Subject: Zion Station Units 1 and 2
I.E. Bulletin 80-11, Masonry Walls
NRC Docket Nos. 50-295 and 50-304

ZION STATION UNITS 1 and 2

RESPONSE TO REQUEST FOR ADDITIONAL INFORMATION
ON
MASONRY WALLS

WALL A-579-9A SOUTH ELEV.
SCALE: 1/4" = 1'-0"

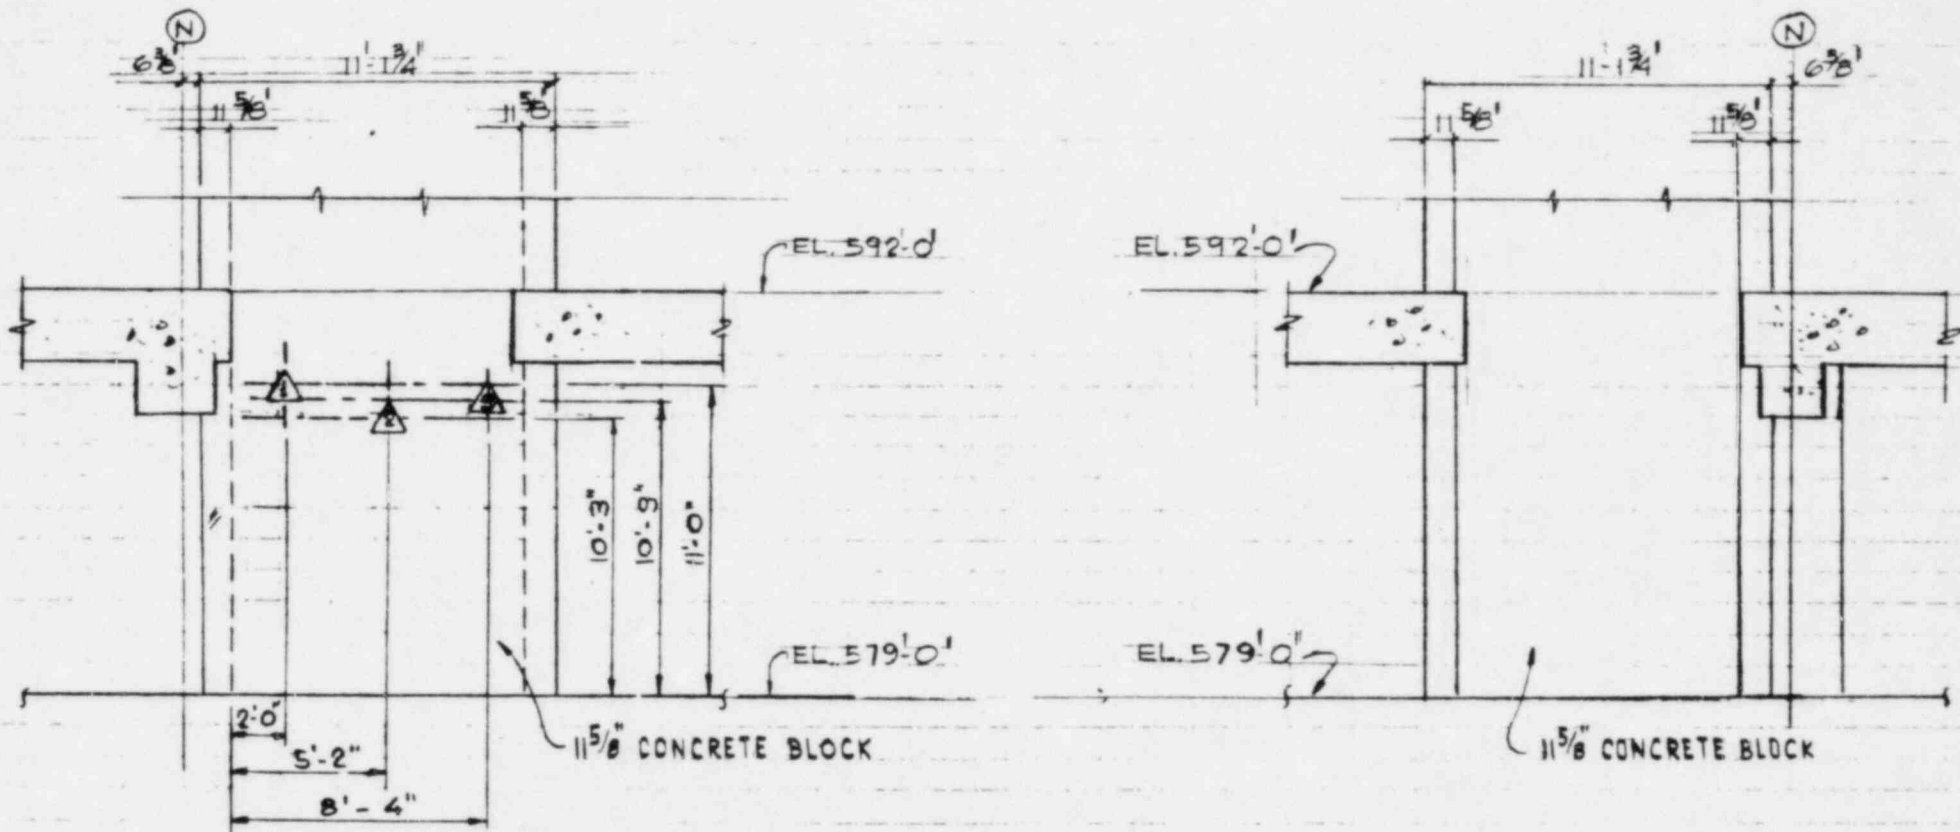
4. Provide the number of unreinforced walls and a sample calculation illustrating the analytical approach used for single-wythe and multiple-wythe wall.

7. Indicate the mode of failure of each wall not qualified under the working condition. Provide details of proposed modifications for each wall with sketches and demonstrate through sample calculations that the wall will be qualified after modification.

There are a total of 130 safety-related walls at Zion, 100 of which are single-wythe construction. Of these, 86 walls are unreinforced. A sample calculation illustrating the analytical approach is attached for your reference.

The information regarding walls originally found to be not qualified is on file with our Architect Engineers and is available for your review at their offices. A sample calculation has been included in response to Question Number 4.
